Project Updates

CPC Subcommittee

University of Oregon Oregon Bach Festival

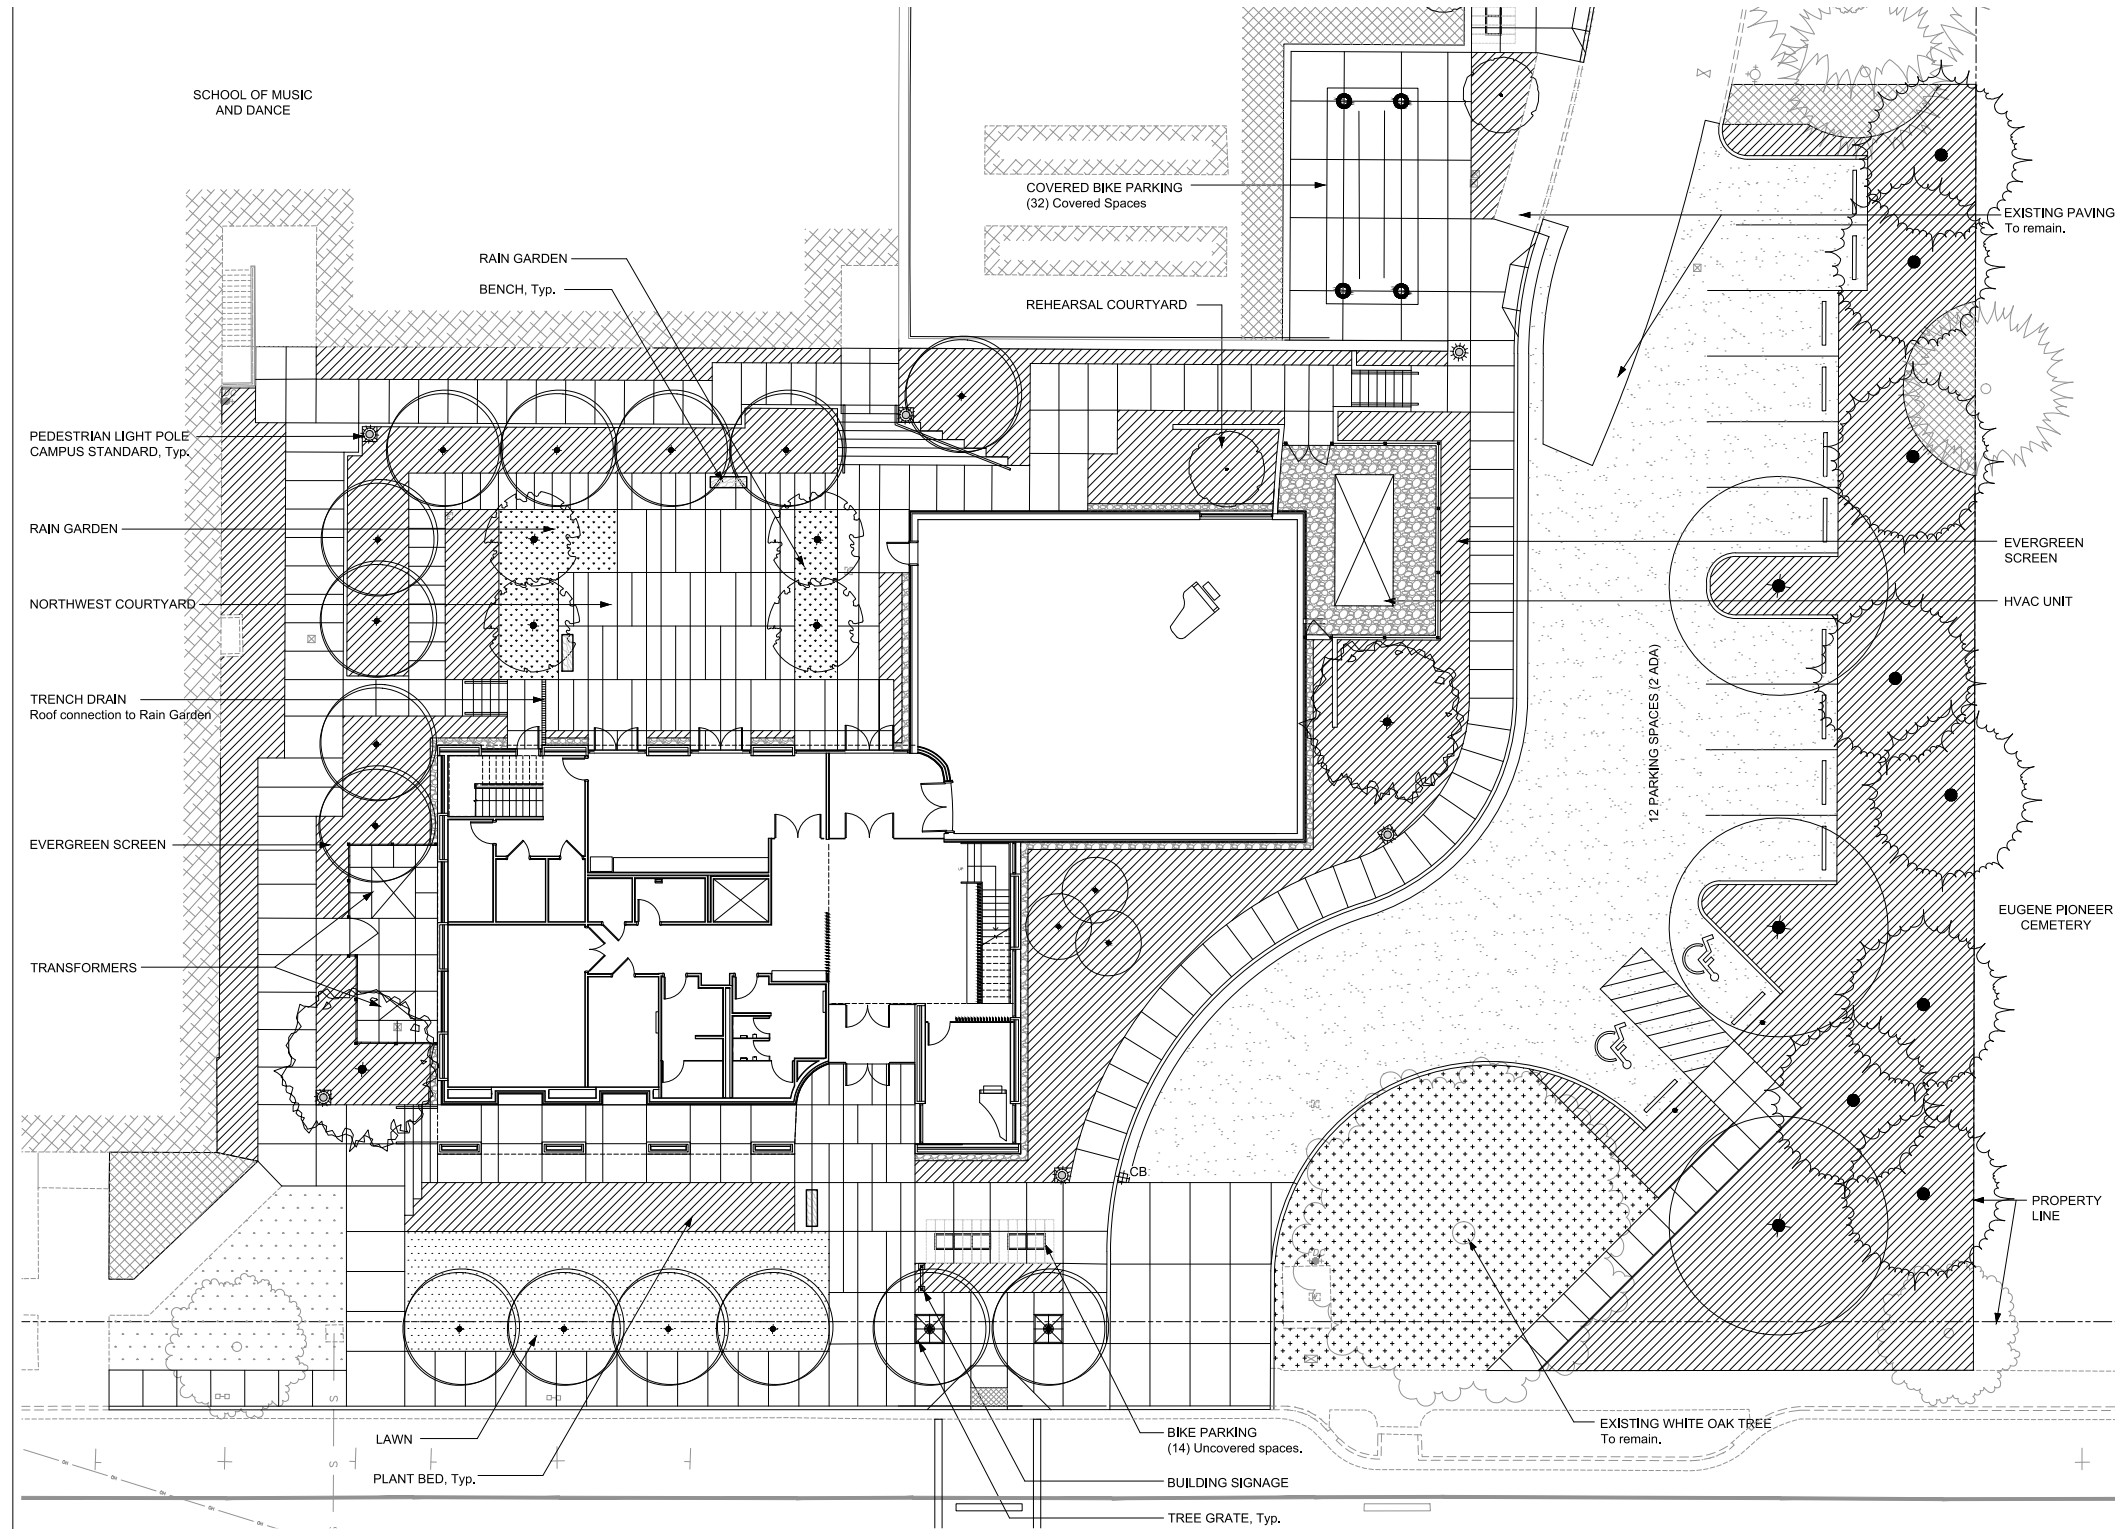
The committee agreed unanimously that the proposed landscape design revisions for the Oregon Bach Festival (OBF) Music Building Addition Project are consistent with the Campus Plan and recommended to the president that they be approved subject to the following conditions:

1. Ensure ease of access (e.g. by means of a curb cut) for bikes from the driveway to bike parking.
2. Work with Campus Ops staff to allow continued access to and ease of maintenance of the existing green roof on the School of Music and Dance.
3. Continue to look for ways to enhance the shared use of the courtyard, particularly with regards to solar access (while recognizing the intended programmed use of the courtyard).
4. Work with Campus Ops and Campus Planning staff to review the proposed bench design.
